Staff Report

To: Salt Lake City Planning Commission
From: Kelsey Lindquist (385) 226-7227
Date: October 13, 2021
Re: PLNPCM2021-00651 and PLNPCM2021-00071

Planned Development and Design Review

REQUEST: Ryan Mackowiak with Aeurbia, project representative, is requesting Planned Development and Design Review approval for a multi-family development, known as The Huxley, located at 74, 64 and 52 S. 600 W. and 618 W. 100 S. The proposal is for a 220-unit apartment building on a 1.10 acre site. The building will be approximately 85 feet in height. The property is located in the G-MU (Gateway Mixed-Use) zoning district. The G-MU zoning district required Planned Development approval for all new principal buildings. In addition, Design Review approval has been requested to address exterior material choices used on upper floors of the building and the additional 10 feet of building height.

Proposed Landscape Plan and Park Strip Installation

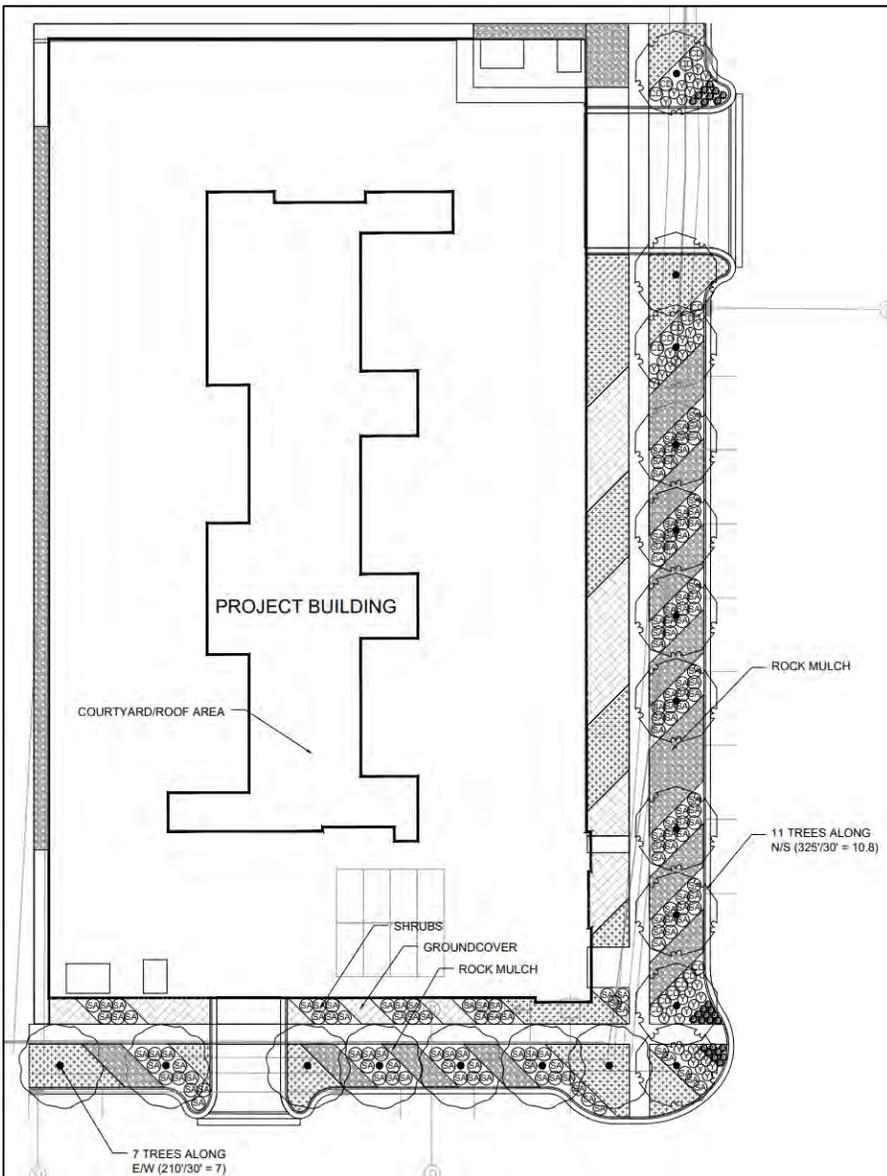
Upon submitting the Planned Development application, the applicant desired to install cut-in parking within the 100 South and 600 West park strips. Currently, this location of both 600 West and 100 South does not have a well-established or landscaped park strip. Staff worked with the applicant and Transportation to modify the proposal of cut-in parking to on-street parallel parking with a restored and landscaped park strip. The new park strip will be approximately **16.28'** with a **new 6' sidewalk**. **The new park** strip will be an improvement to the existing lack of street trees and established landscaping on the subject property.

1. **On 600 W, the park strip shall widened eight feet (8') toward the center of the street and new curb and gutter shall be installed.**
2. On 100 S, show how the drainage ditch will be handled (piped/buried or left as is) and show curb and gutter with parallel parking. If the ditch is buried, then the park strip shall be widened eight feet toward the center of the road.

The reason for these modifications is to ensure that there is adequate park strip for the planting of trees and (on 600 W) to avoid the situation where vehicles are backing into the existing bike lane.

D3	Whether proposed landscaping is designed to lessen potential impacts created by the proposed planned development; and	Complies	The development includes reinstating the park strip with landscaping, street trees and a sidewalk.
D4	Whether proposed landscaping is appropriate for the scale of the development.	Complies	The amount and scale of the proposed landscaping is appropriate for the housing development.
